Quality Alert

N° of Alert:2024-mar-008	*Date 18/03/2024*	*update of Alert:*
Customer Plant: AVO/SCEET Fahs	Supplier: AVO GERMANY	
Customer Contact:bassem.benmallek@avocarbon.com	Editor: Belgacem Brika

Part number:	A60101942(1026047)	When did it happened:	16/03/2024
Part name:	Carbon brush	Who detected it	technician
Batch number:	278419	Where was it detected	at incomming inspection
Recuerrence defect:	yes	How was it detected	by measures
Demerit:		How many parts:	4pcs

ok Part (Sketch - Picture)

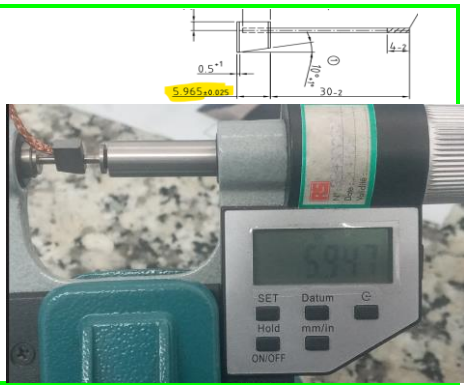
1- Porblem Description :bush was manufactured with dimension 5,965 not conform in minimum
2- Why is it a problem: the height of this carbon brush is too small

Moyen de contrôle utisé par la Tunisie différent de celui utilisé à Poitiers

5,908;5,898;5,928;5921,....
